SUBJECT: ADMINISTRATIVE ORGANIZATIONAL CHANGES - OYSTER CREEK

OYSTER CREEK NUCLEAR GENERATING STATION

Amendment No. 65  
License No. DPR-16

SUPPORTING AMENDMENT NO. 65 TO PROVISIONAL OPERATING LICENSE NO. DPR-16

**FIGURE 6.2.2**  
**ONSITE ORGANIZATION**

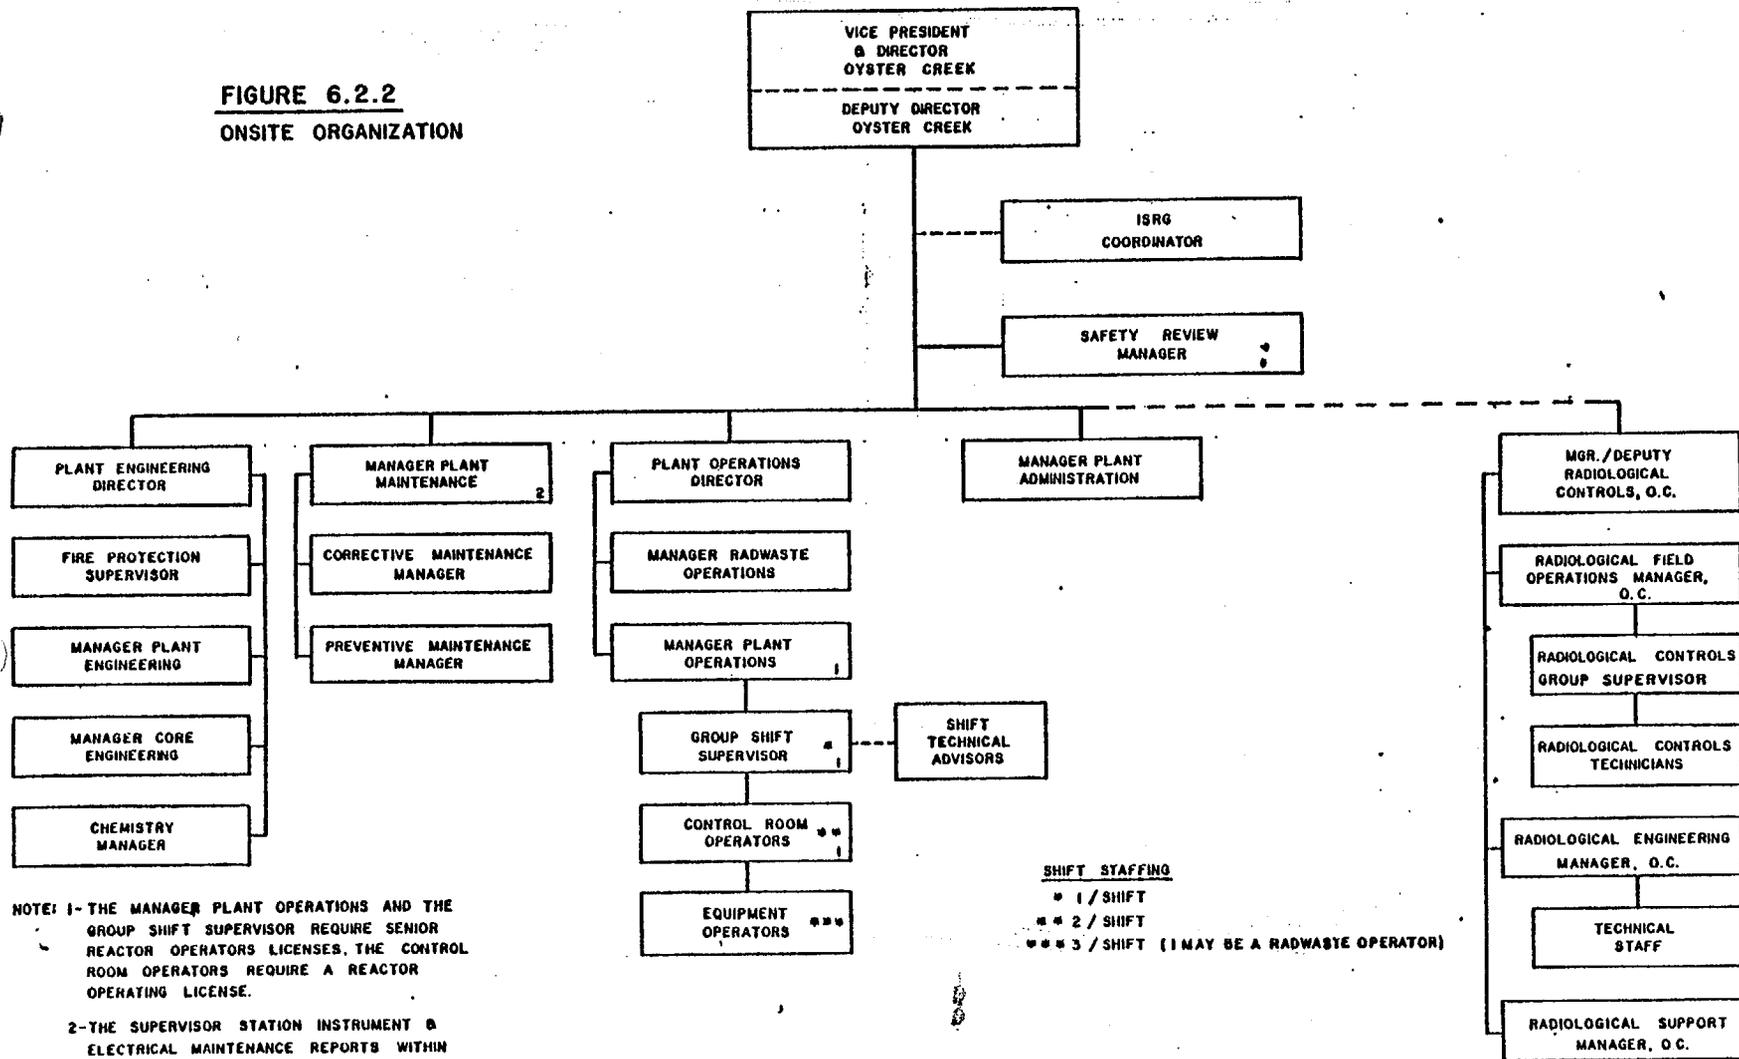
In addition, the licensee proposes to add a note to Figure 6.2.2 concerning the manning of equipment operators. At the present time an onshift equipment operator is assigned on an as needed basis to be a radwaste operator. This change would require the radwaste operator to be a full-time position and would be considered part of the minimum shift staffing of equipment operators.
